## Staff Report to the Zoning Administrator

Application Number: **07-0412**

**Project Description:** Proposal to recognize a 320 square foot AT&T equipment enclosure constructed within the Highway 1 right of way. Requires a Coastal Development Permit.

EXHIBIT A

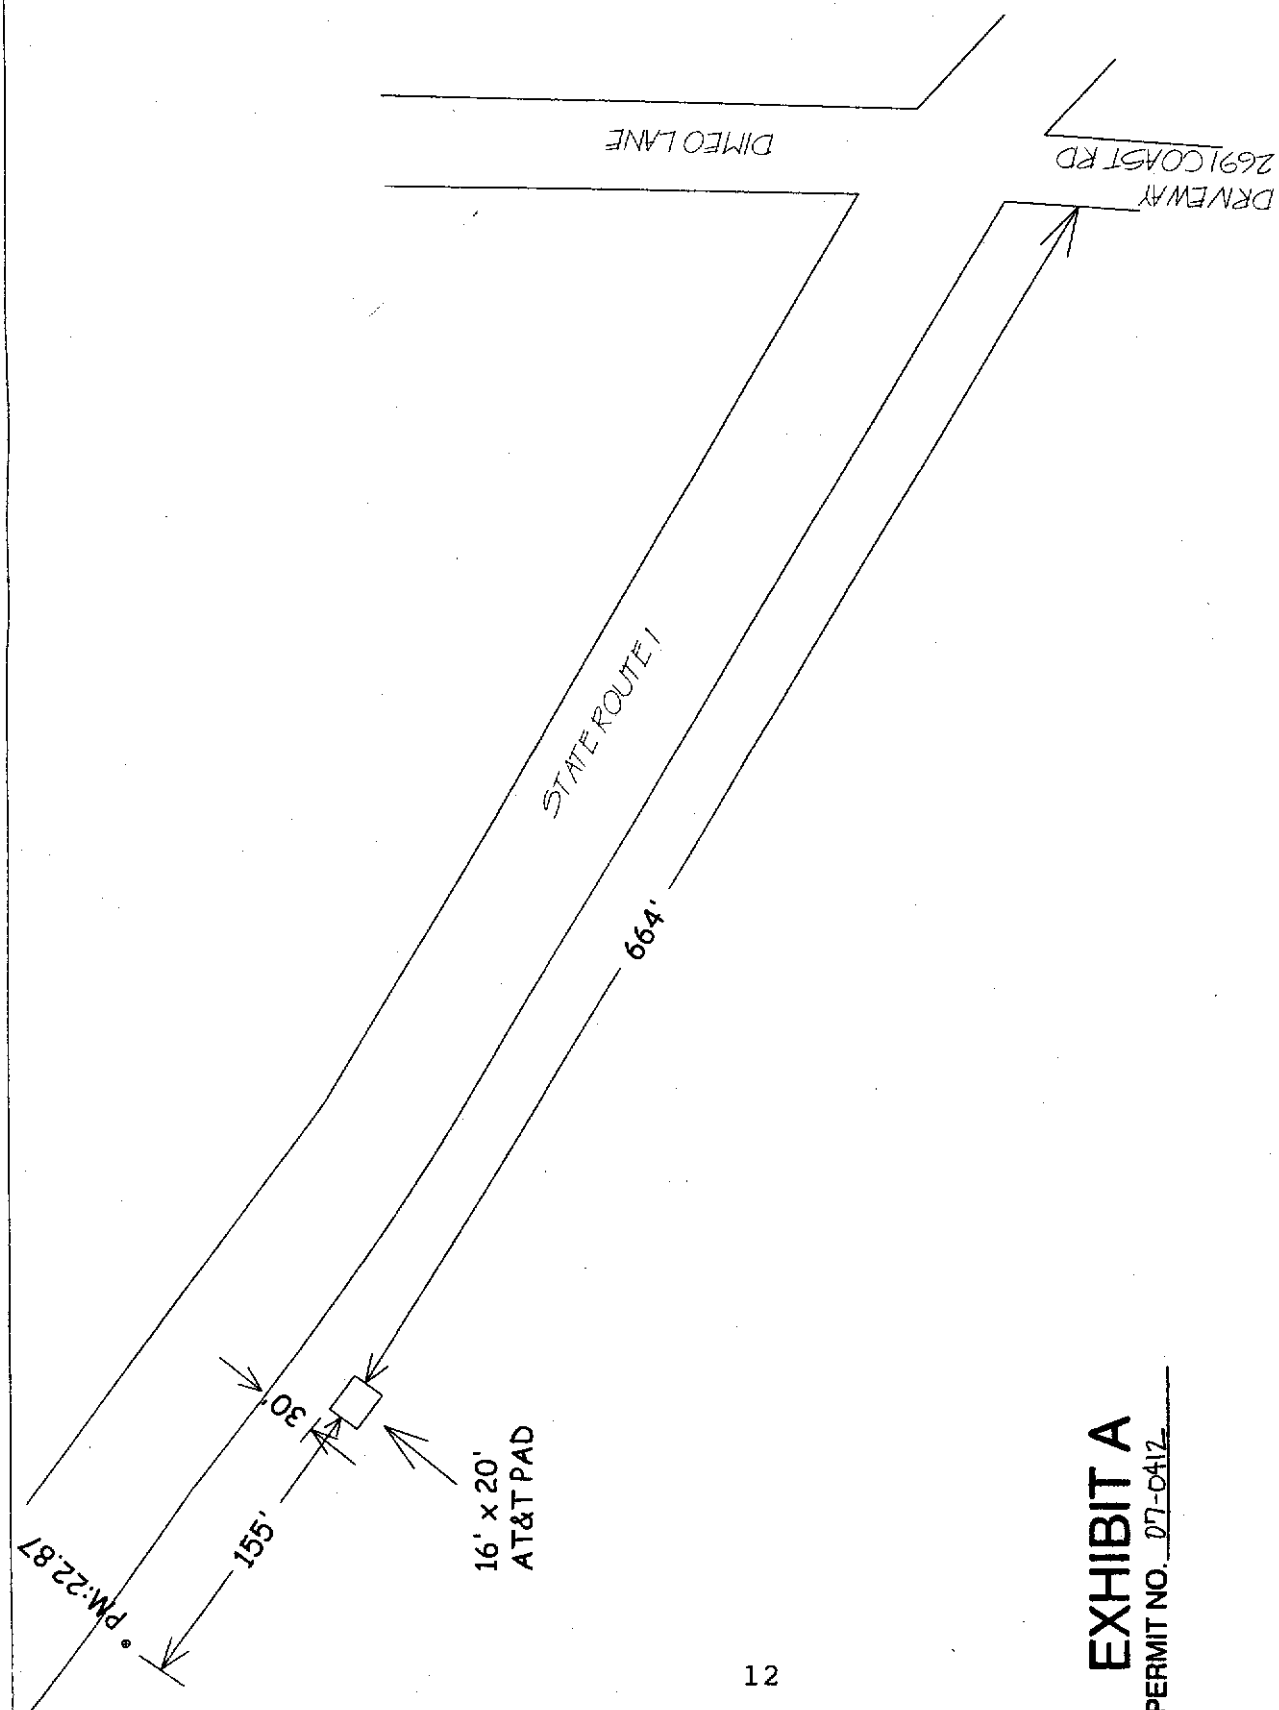
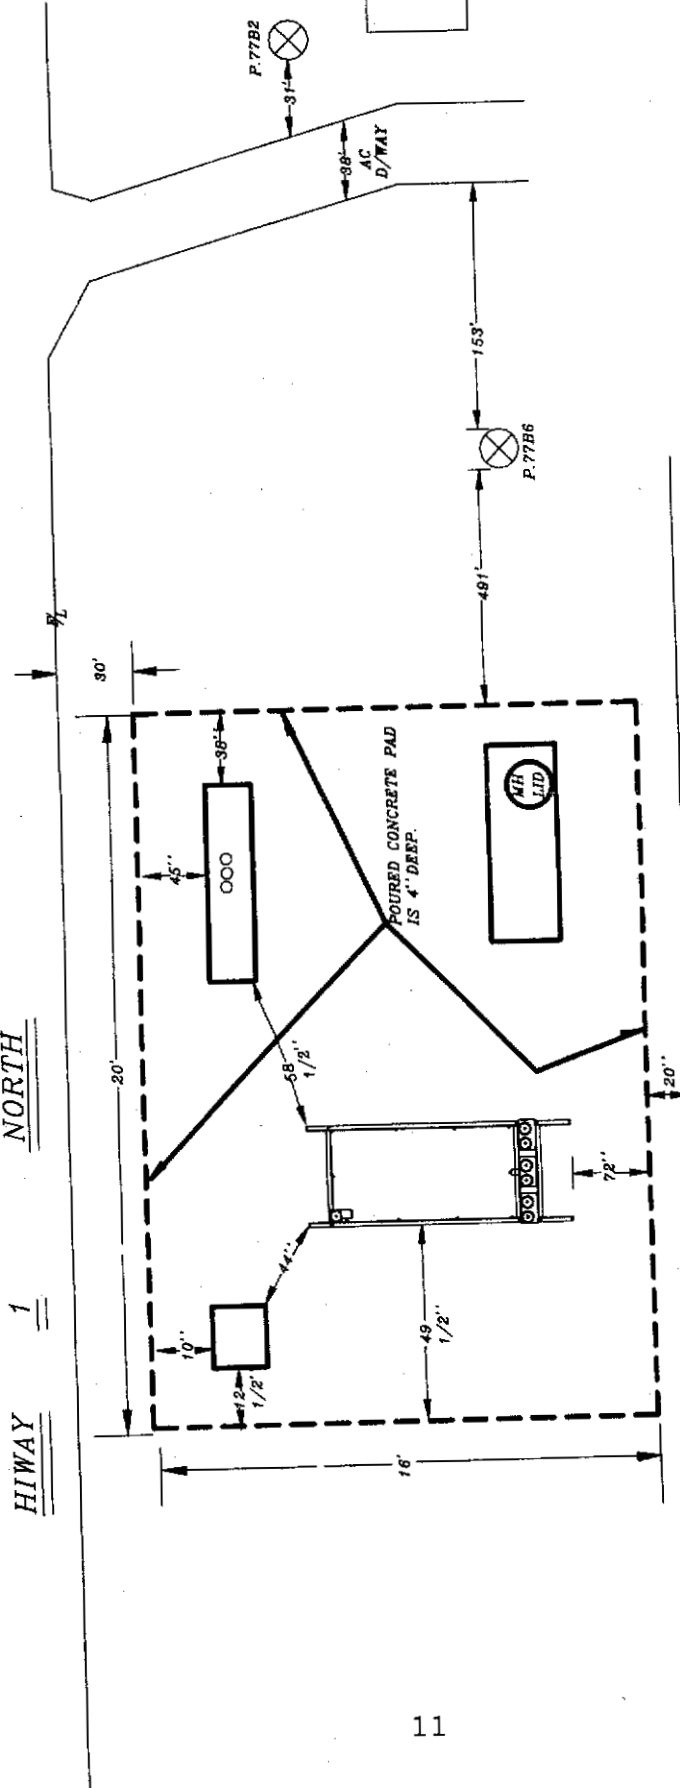
County Code 13.20.130(b)1 requires that all development in the Coastal Zone be sited, designed and landscaped to be visually compatible and integrated with the character of the surrounding areas. In this case, the area is agricultural in character. While the projects plans show that the applicant proposes to replace the existing chain link fence with a wooden fence and landscaping, this proposal would be out of character with the area since (as noted above), there is little ornamental vegetation in the vicinity. In addition, maintenance of the enclosure appears to be an issue. As the photo in Exhibit A shows, the negative visual impact of the enclosure is increased by graffiti. Because of the enclosure's isolated location along a highway, graffiti is likely to continue to be an issue regardless of the type of fencing used or the vigilance of any maintenance program.

setting carefully so that "its presence is subordinate to the natural character of the site...". The existing enclosure dominates the natural character of the site in that the enclosure obstructs views of the agricultural fields and the Pacific Ocean beyond. The enclosure is visible for approximately one-quarter mile in either direction. Given the close proximity to the highway, the enclosure breaks up the wide views available to drivers and bikers along this stretch of the highway.

recommended that the facility be placed underground in the existing location or moved to a visually superior site. The applicant declined to pursue either of these alternatives. With visually superior alternatives available, maintaining the existing site would not constitute retaining the ocean vista to the "maximum extent possible."

ENCLOSURE  
OFF HWY 1

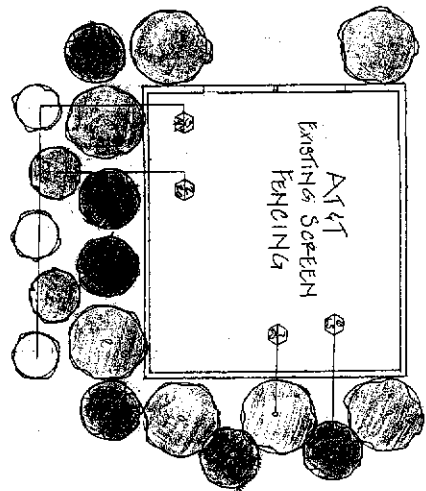
General Plan Policy 5.10.3 (Protection of Public Vistas) requires the protection of significant public vistas by minimizing, among other things, inappropriate landscaping and structure design. Landscaping is generally used as a means to soften the impact of development when that landscaping is not, in itself, a visual impact. Because there is no ornamental landscaping in the vicinity, the proposed landscaping does not mitigate the impact of the development but, rather, amplifies that impact. In addition, even with wooden fencing to replace the chain link fence, the structure is out of character with the surrounding area. Agricultural buildings are typically clustered together to preserve arable land while the subject enclosure stands alone. In addition, this enclosure is a fence encircling equipment for which there is no nearby analogous agricultural structure. Therefore, both the landscaping and structure are inappropriate for this area.
